Subject: Duke Energy Carolinas, LLC  
Oconee Nuclear Station (ONS), Units 1, 2, and 3  
Docket Numbers 50-269, 50-270, and 50-287  
License Amendment Request to Update Pressure-Temperature Limit Curves  
License Amendment Request (LAR) No. 2012-10

Subject: License Amendment Request to Update Pressure-Temperature Limit Curves  
License Amendment Request (LAR) No. 2012-10

**ATTACHMENT 1**  
**TECHNICAL SPECIFICATION**  
**MARK UPS**

Figure 3.4.3-7 (page 1 of 1)  
RCS Normal Operational Heatup Limitations  
Applicable for the First 33 EFPY - Oconee Nuclear Station Unit 3

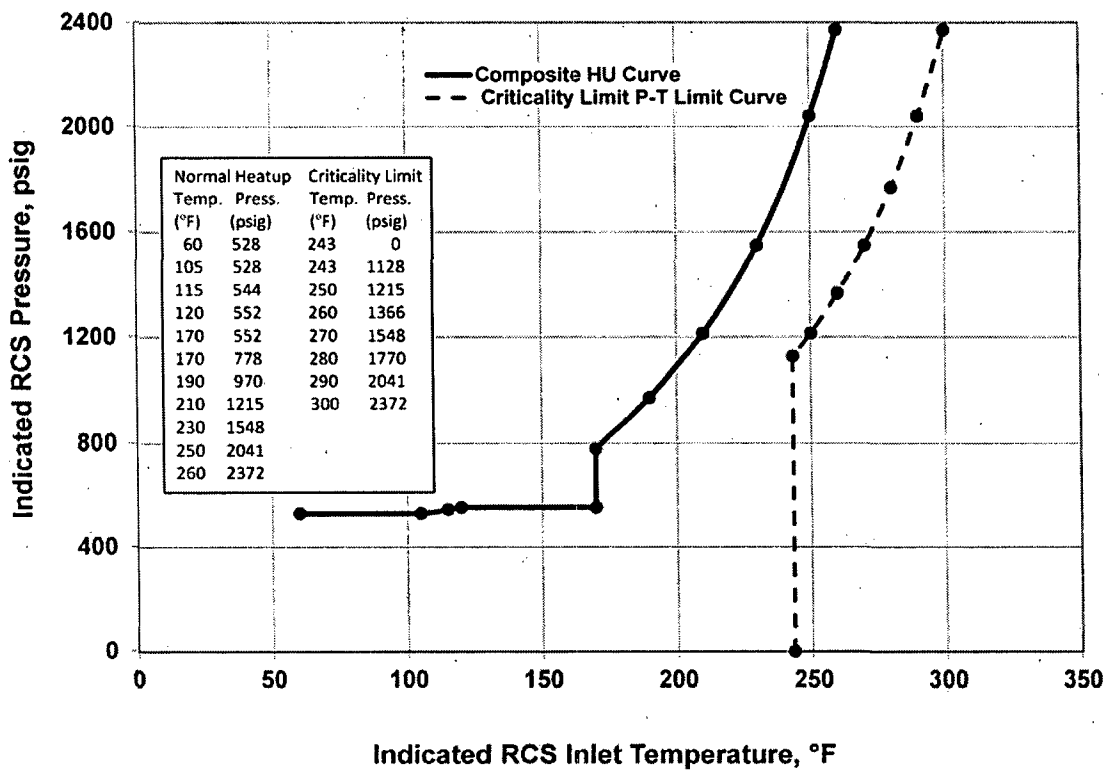
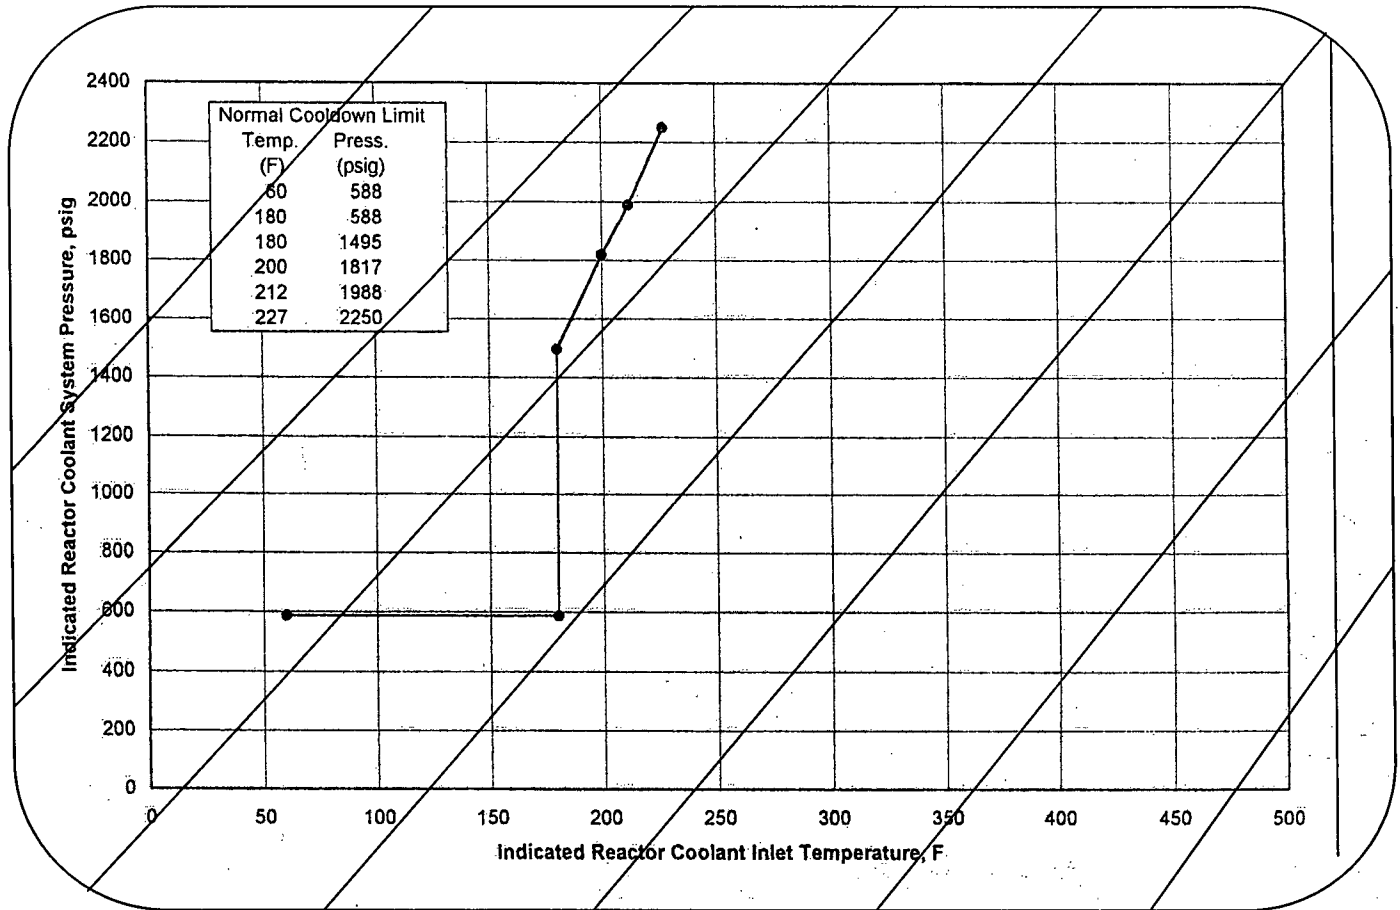
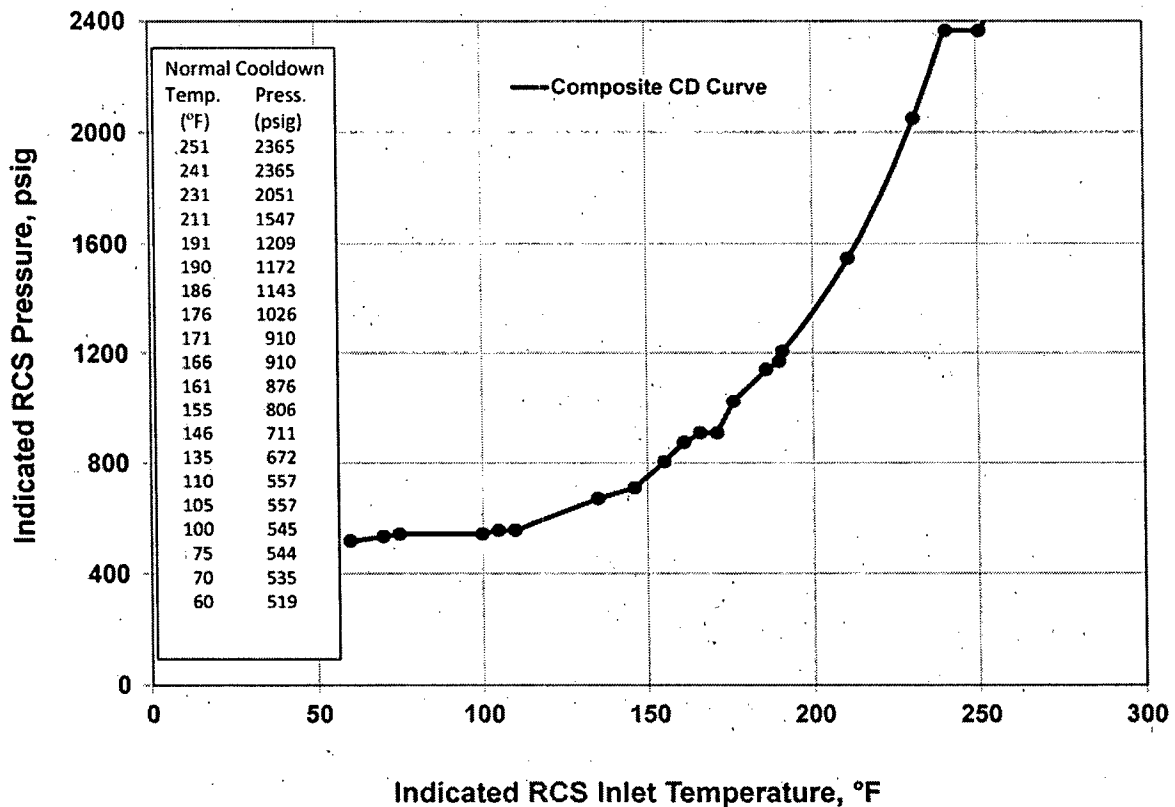
TS Limiting Condition for Operation (LCO) 3.4.3 currently provides the P-T limits for RCS Normal Operational Heatup Limitations, RCS Normal Operational Cooldown Limitations, and RCS Leak and Hydrostatic Test Heatup and Cooldown Limitations applicable to the first 33 EFPY in Figures 3.4.3-1, 3.4.3-2 & 3.4.3-3 respectively for ONS-1, in Figures 3.4.3-4, 3.4.3-5, & 3.4.3-6 respectively for ONS-2, and in Figures 3.4.3-7, 3.4.3-8, & 3.4.3-9 respectively for ONS-3. The proposed change would replace the existing P-T limits for 33 EFPY with P-T limits for 54 EFPY. Also, changes to the operational requirements for unit heatup and cooldown in TS Tables 3.4.3-1 and 3.4.3-2 are proposed. These changes are supported by the new 54 EFPY P-T limits. The proposed changes are depicted in the TS markup and retype provided in Attachments 1 and 2.

INSERT G

Figure 3.4.3-7 (page 1 of 1)  
RCS Normal Operational Heatup Limitations  
Applicable for the First 54 EFPY - Oconee Nuclear Station Unit 3

Figure 3.4.3-8 (page 1 of 1)  
RCS Normal Operational Cooldown Limitations  
Applicable for the First 33 EFY - Oconee Nuclear Station Unit 3

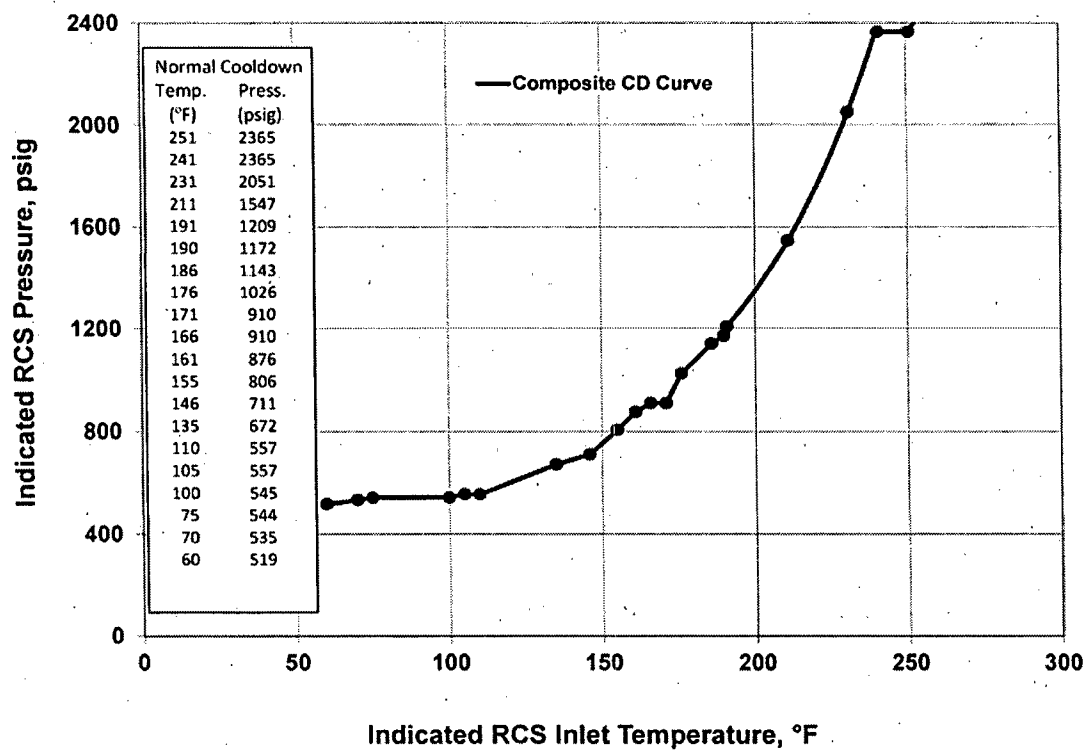
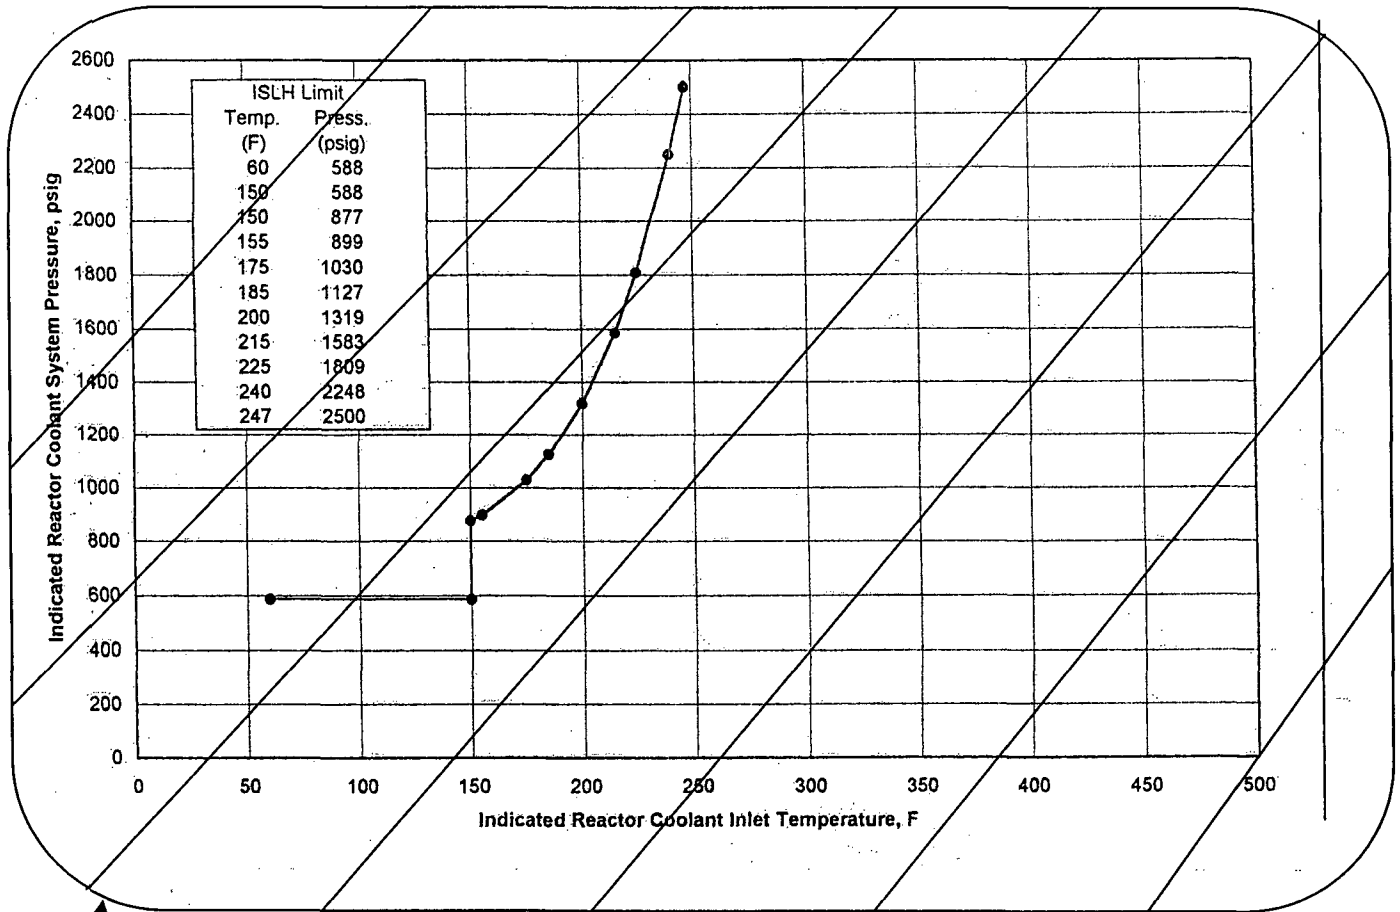
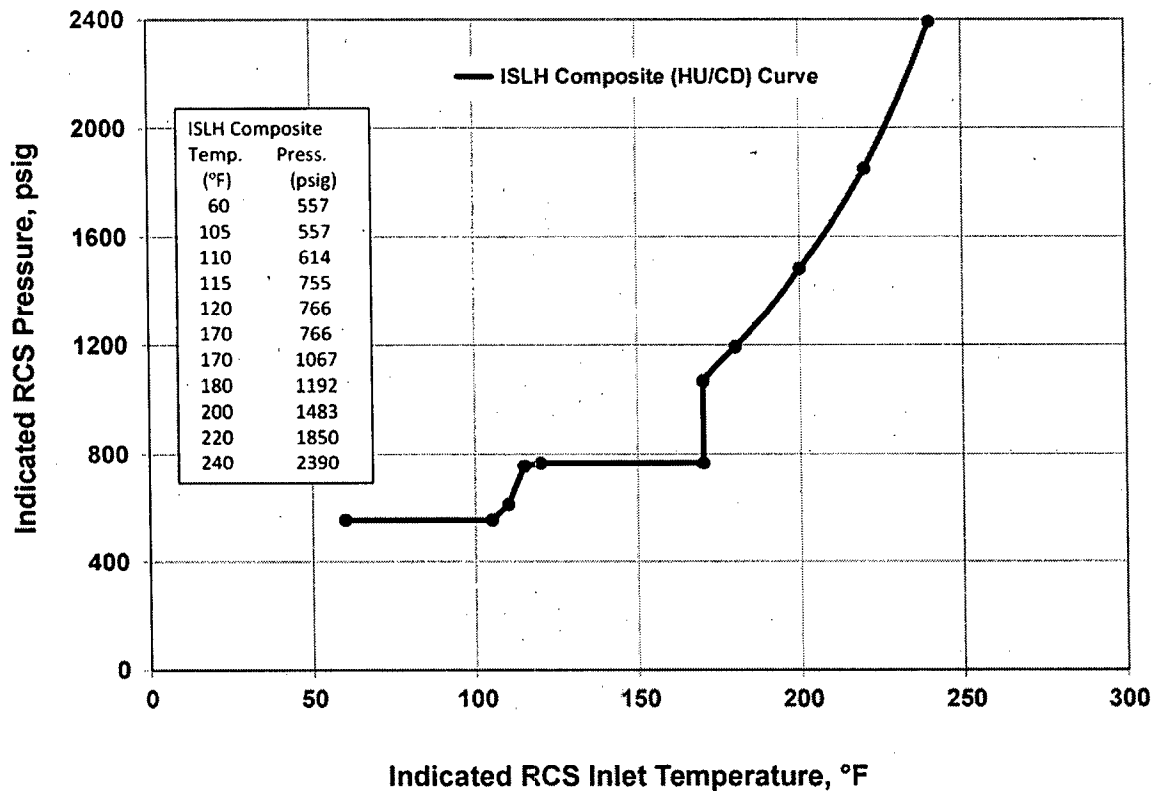
INSERT H

Figure 3.4.3-8 (page 1 of 1)  
RCS Normal Operational Cooldown Limitations  
Applicable for the First 54 EFPY - Oconee Nuclear Station Unit 3

Figure 3.4.3-9 (page 1 of 1)  
RCS Leak and Hydrostatic Test Heatup and Cooldown Limitations  
Applicable for the First 33-EFPY - Oconee Nuclear Station Unit 3

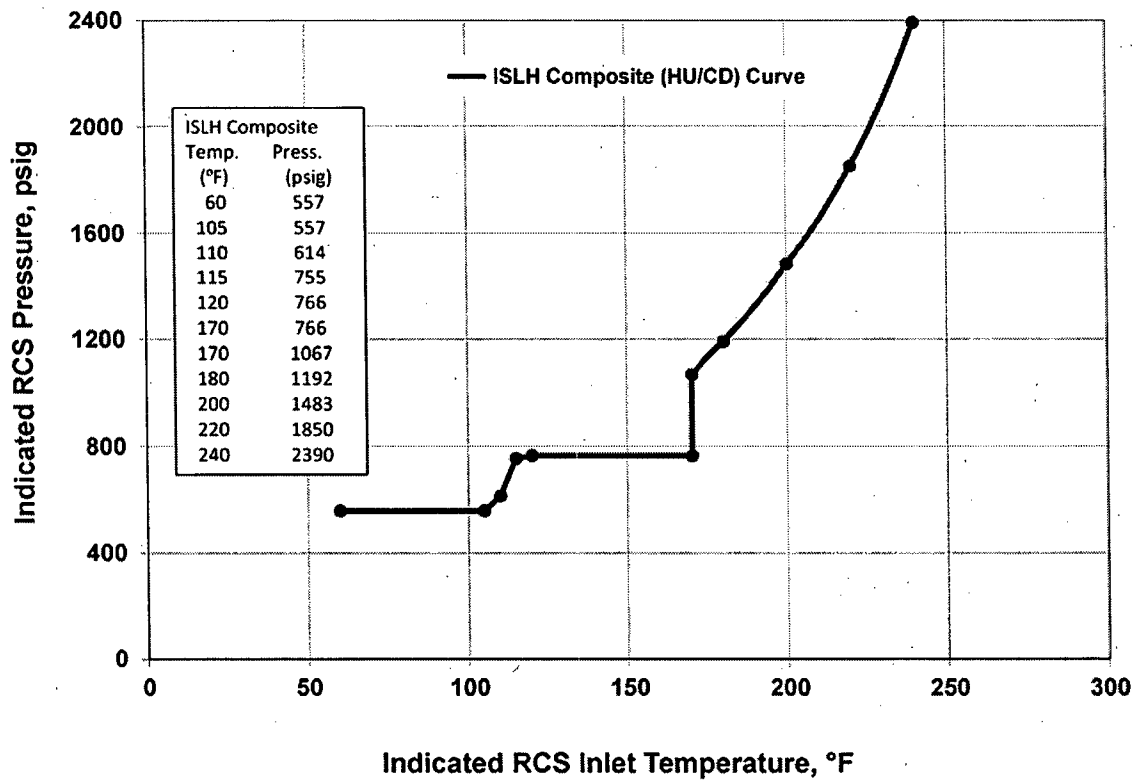
INSERT I

Figure 3.4.3-9 (page 1 of 1)  
RCS Leak and Hydrostatic Test Heatup and Cooldown Limitations  
Applicable for the First 54 EFPY - Oconee Nuclear Station Unit 3
